ADMINISTRATIVE NOTICE

TO: Distribution
FROM: Carlo Costanza, Executive Director
DATE: October 14, 2020
SUBJECT: Revised Drawings

RE: 251-77 Jericho Turnpike BSA application

Below is a list of changes made from the previous BSA application and their narrative descriptions for the above-referenced project.

DRAWING NUMBER:
BSA-001.1

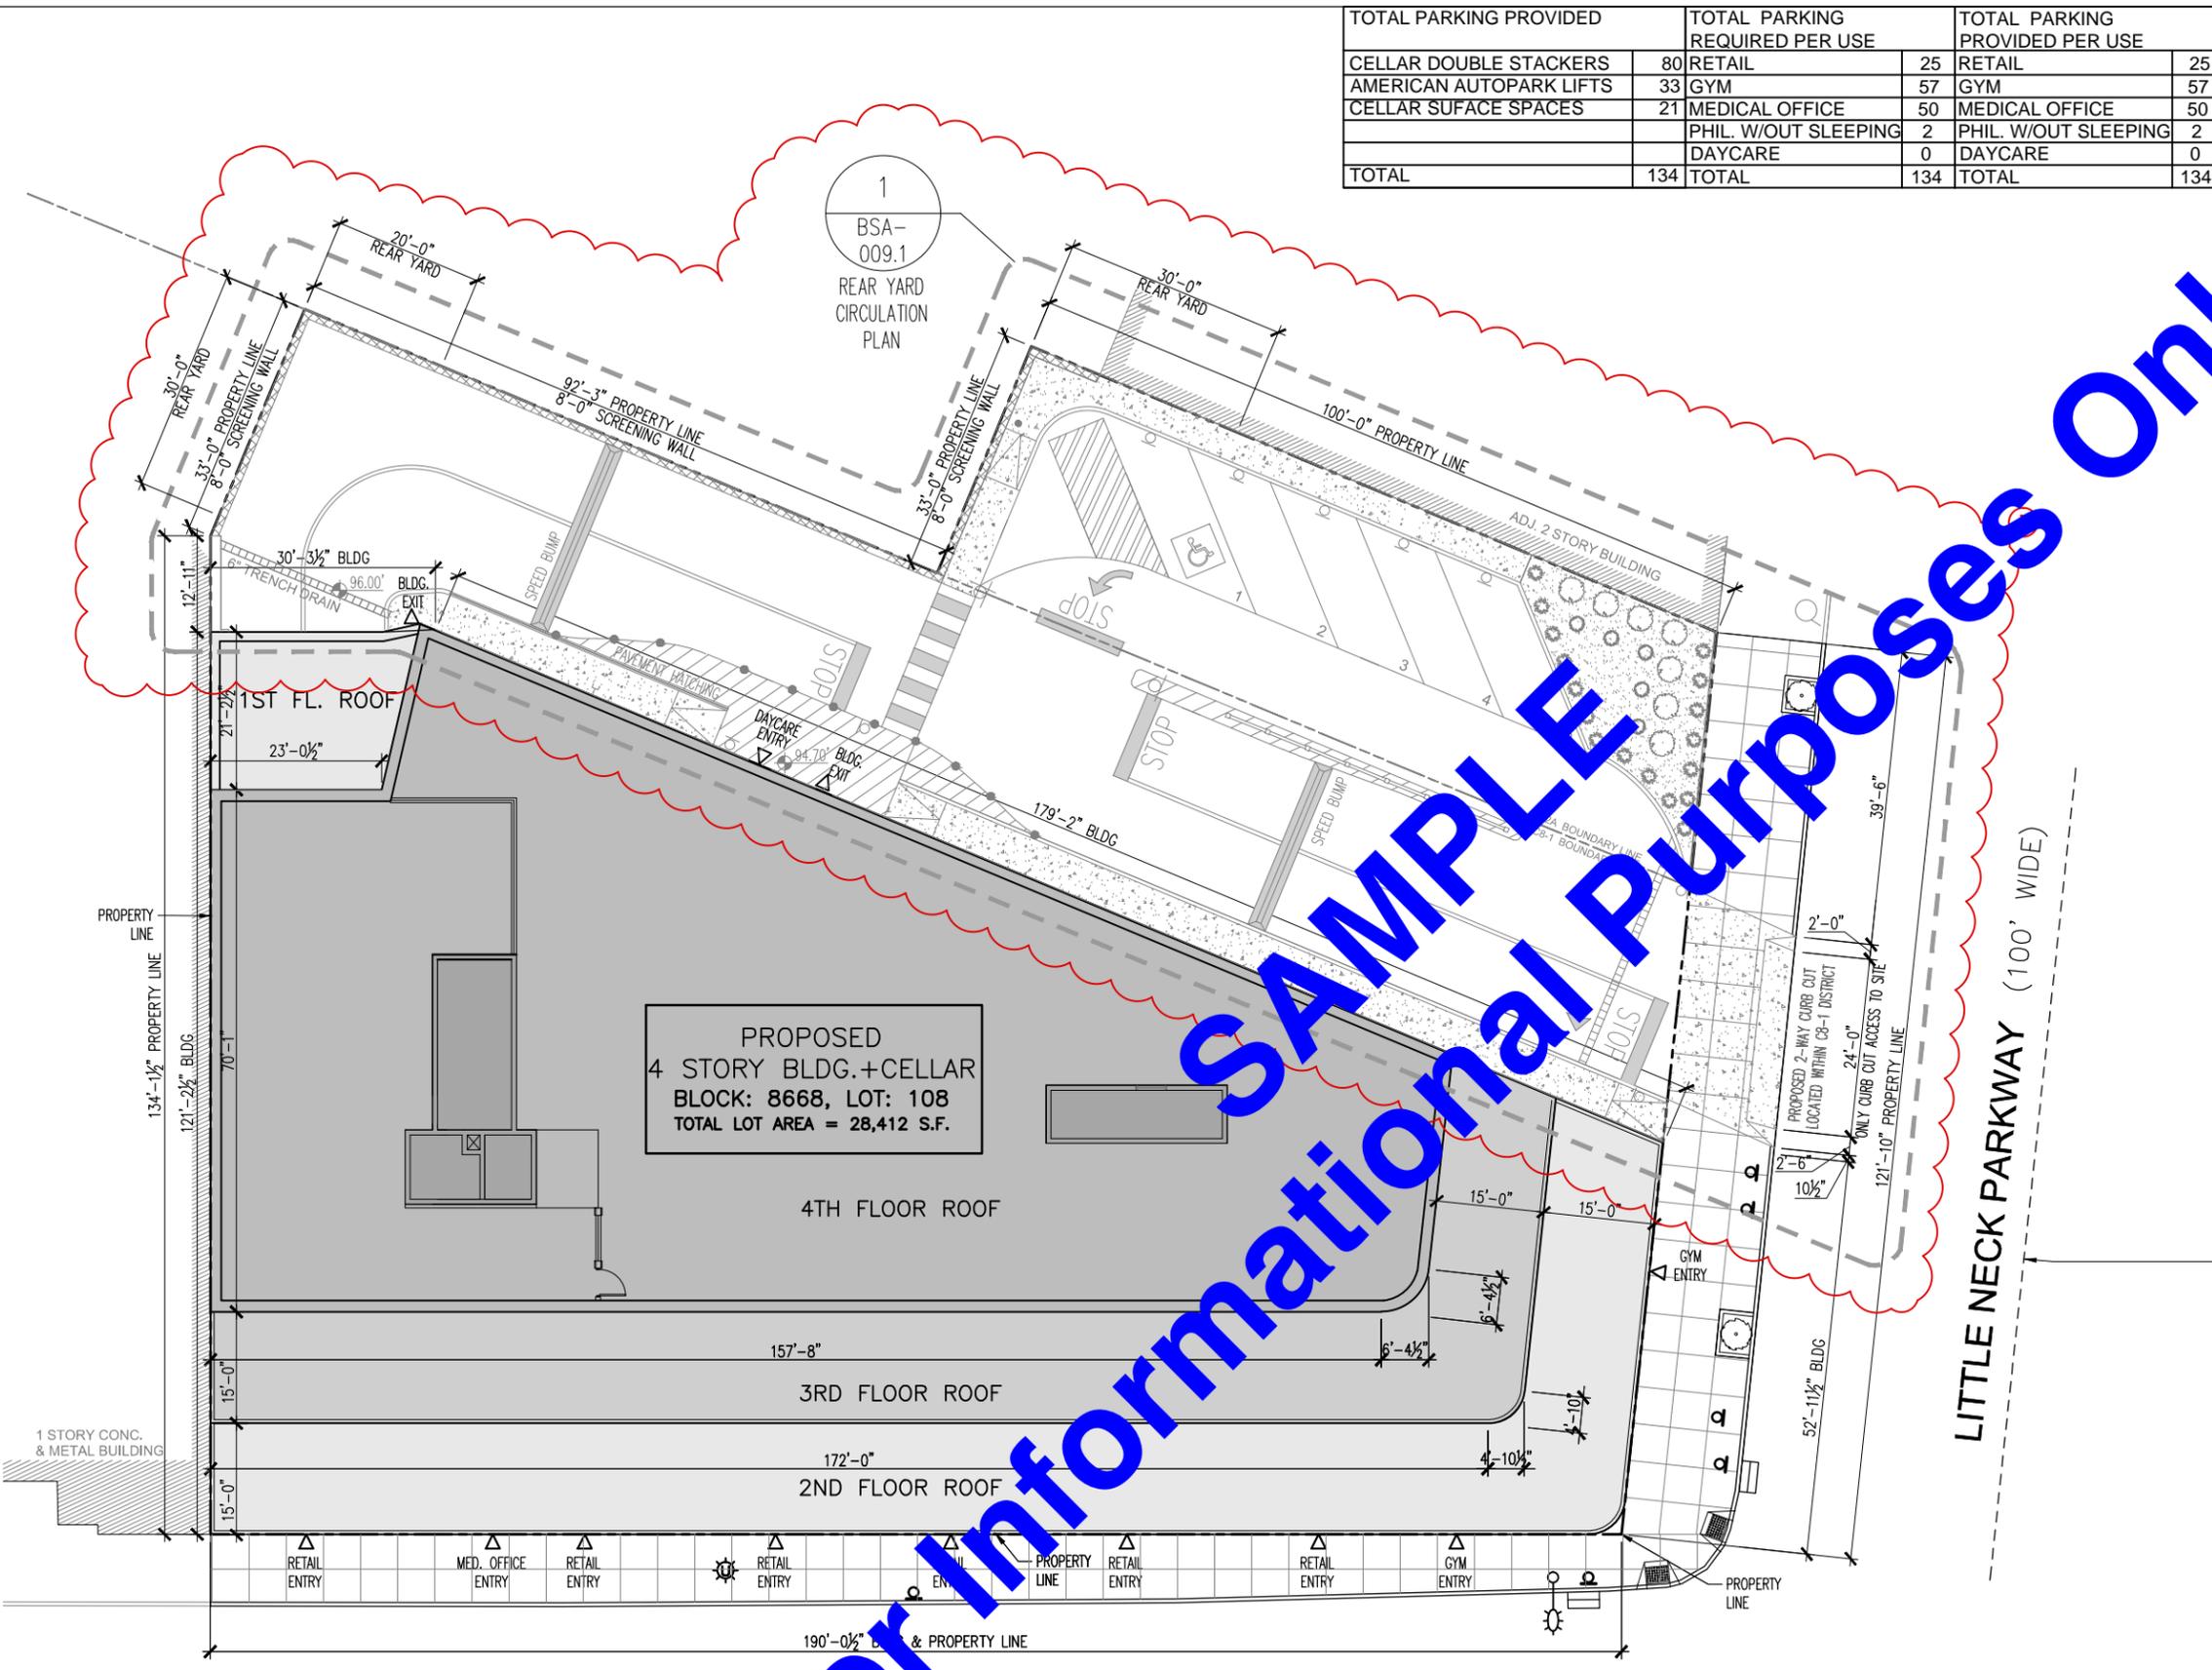
Sheet #	Change #	Changes
BSA-P01.1	1	Number of bicycles provided updated from 14 to 13
BSA-P01.1	2	Calculation for bicycle parking requirements updated
BSA-001.1	3	Vehicle Circulation Plan details now shown BSA-009.1
BSA-002.1	4	Scale bar added
BSA-002.1	5	Hatch graphics updated to clarify tenant access path and fire department access. Vehicle access path added to Leonard.
BSA-002.1	6	Building dimension added
BSA-002.1	7	Building dimension added
BSA-002.1	8	Building dimension added
BSA-002.1	9	Building dimension added
BSA-002.1	10	Building dimension added
BSA-002.1	11	Building dimension added
BSA-002.1	12	Building dimension added
BSA-002.1	13	Building dimension added
BSA-002.1	14	Hatch graphics updated. Elevator signs added. Refrigerated Trash Room added. Refrigerated trash room calculations added. Video intercom (camera) added.
BSA-002.1	15	Number of bicycles provided updated from 14 to 13
BSA-003.1	16	Note added indicating Vehicle Circulation Plan details on a separate sheet

DRAWING NUMBER:
BSA-003.1

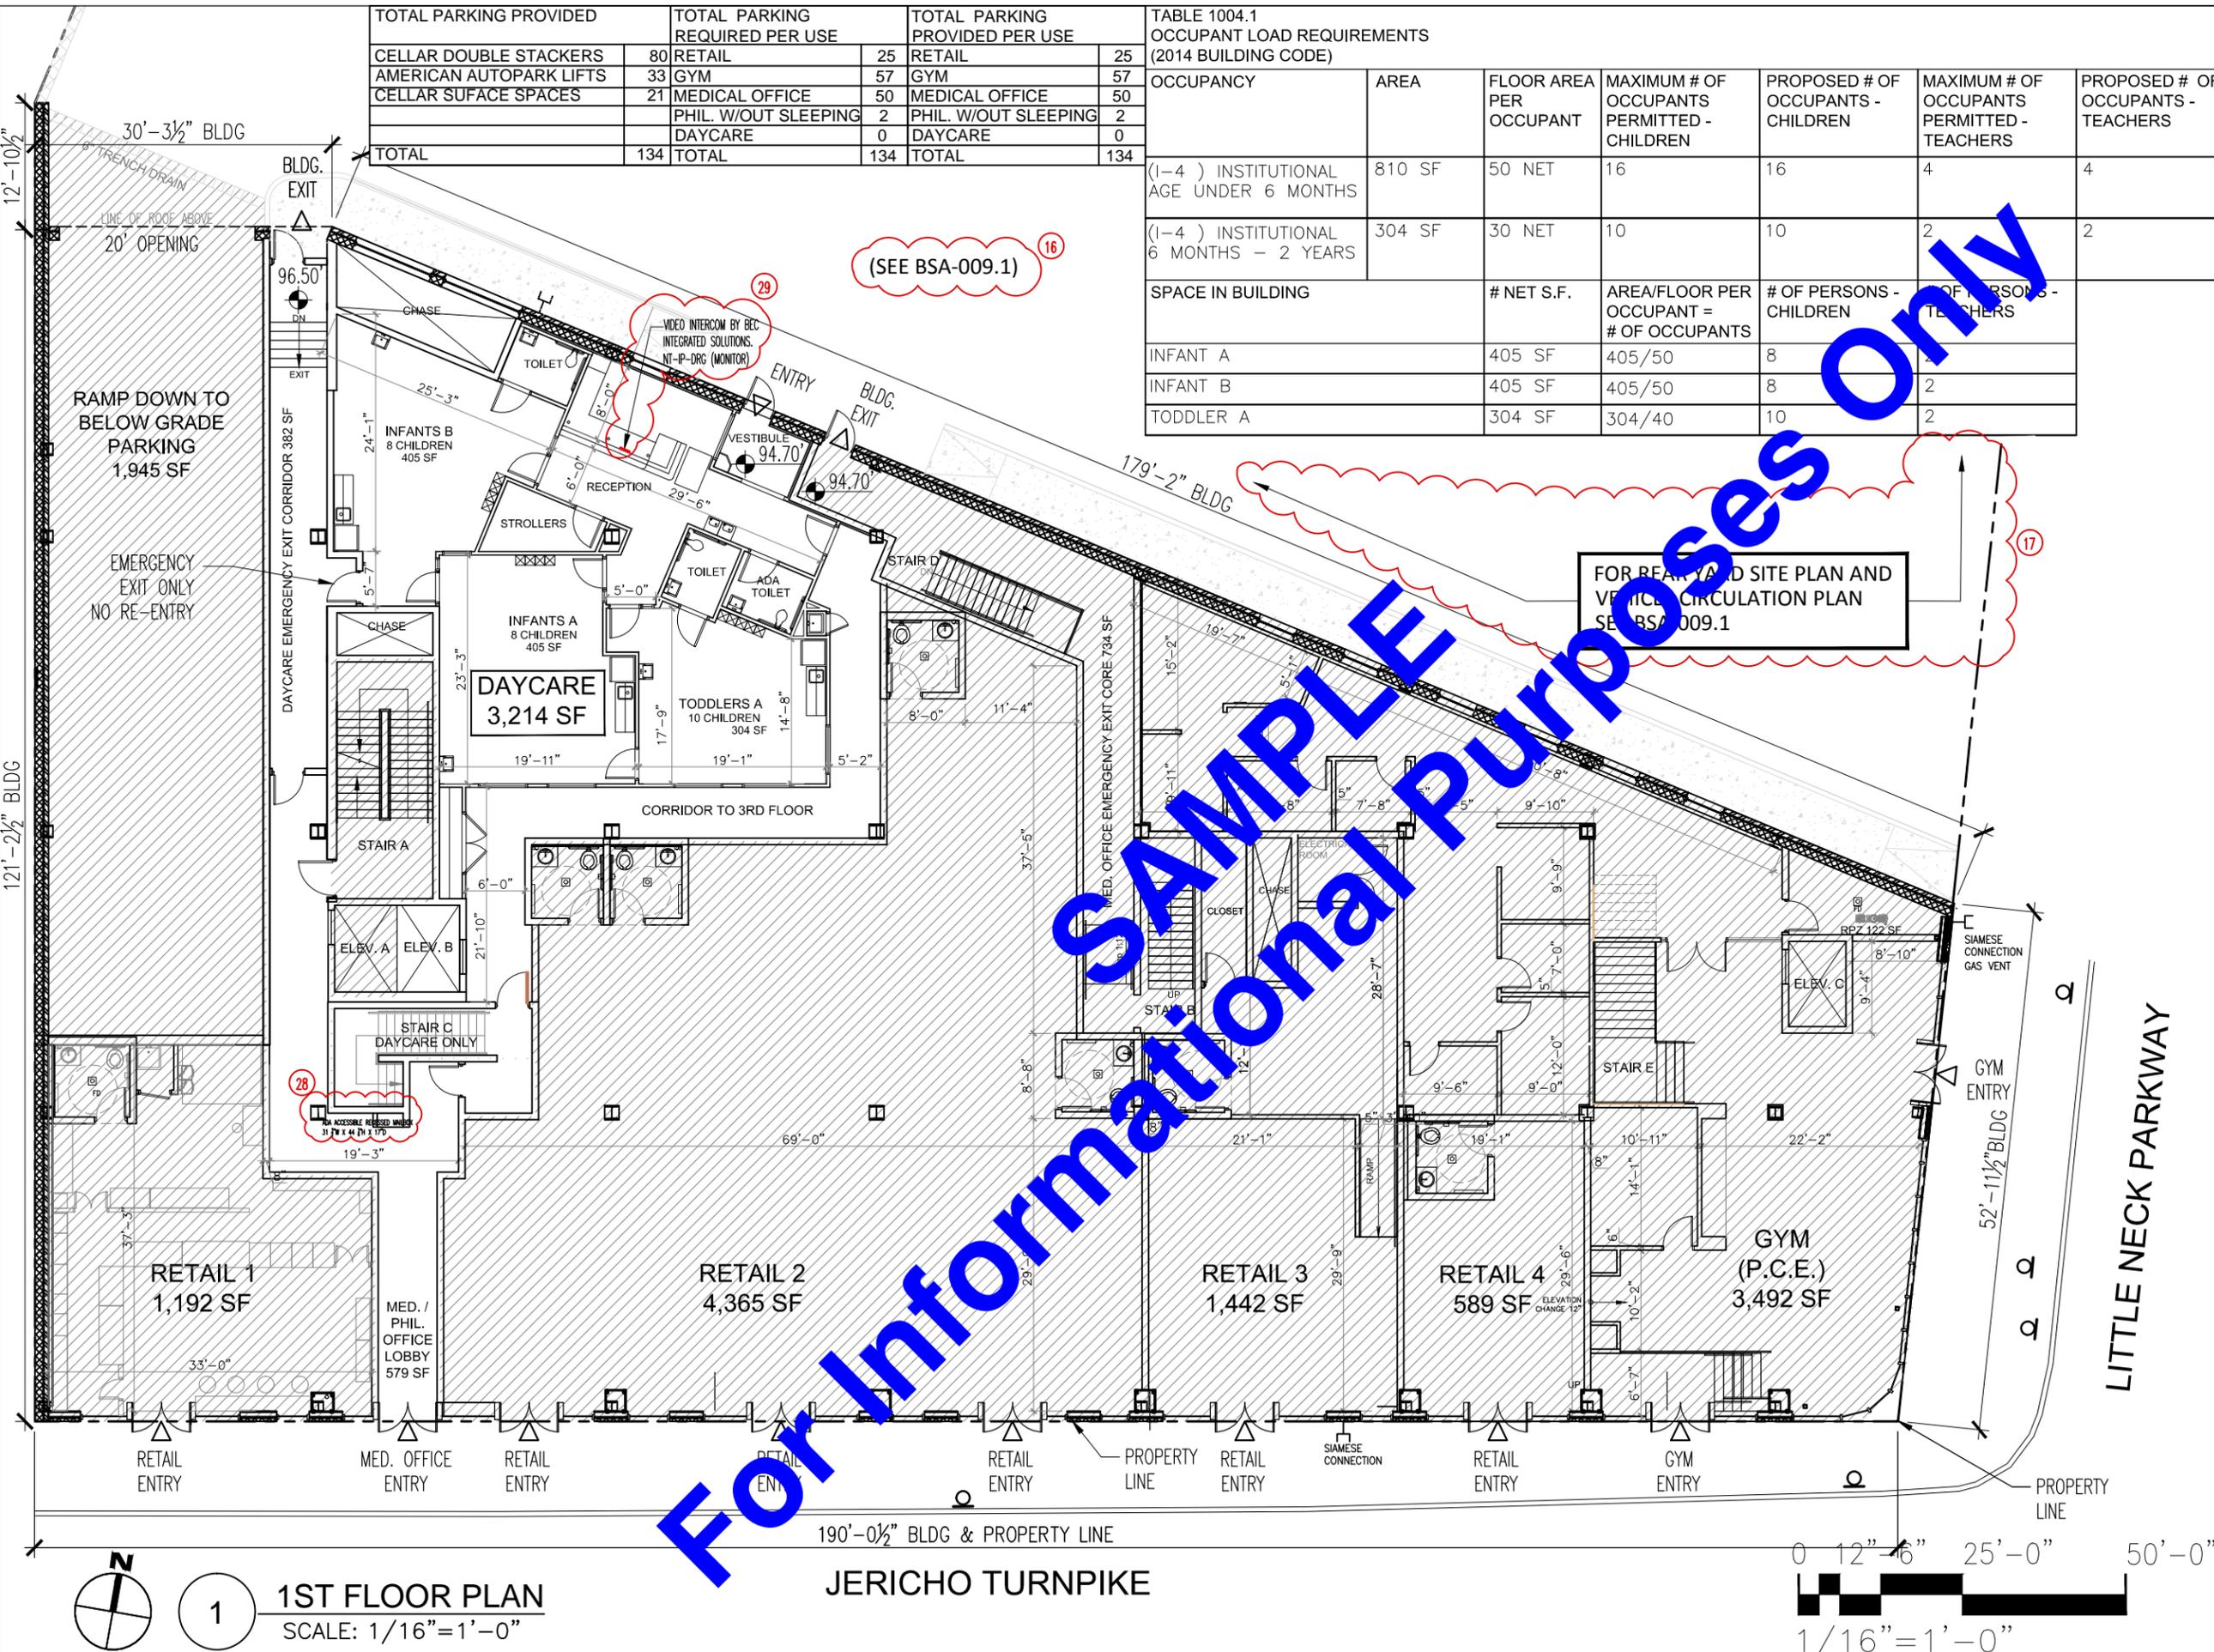
BSA-003.1	17	Note added indicating Vehicle Circulation Plan details on a separate sheet
BSA-005.1	18	Layout of Philanthropic institution updated
BSA-008.1	19	Parking area added
BSA-009.1	20	Scale added and relocated 4' High Vegetated Fence Elevation
BSA-009.1	21	Relocated Daycare drop-off signs to provide more space for the sidewalk
BSA-009.1	22	Parking dimension added
BSA-009.1	23	Note and elevation tag for the vegetated fence added
BSA-009.1	24	Curb cut moved to align with drive aisles and dimensions updated
BSA-009.1	25	Dimension clarified.
BSA-014.1	26	4' High Vegetated Fence Elevation relocated to Sheet BSA-009.1
BSA-002.1	27	Vehicle circulation path added
BSA-003.1	28	Mailbox added
BSA-003.1	29	Video intercom (monitor) at 1 st floor reception added
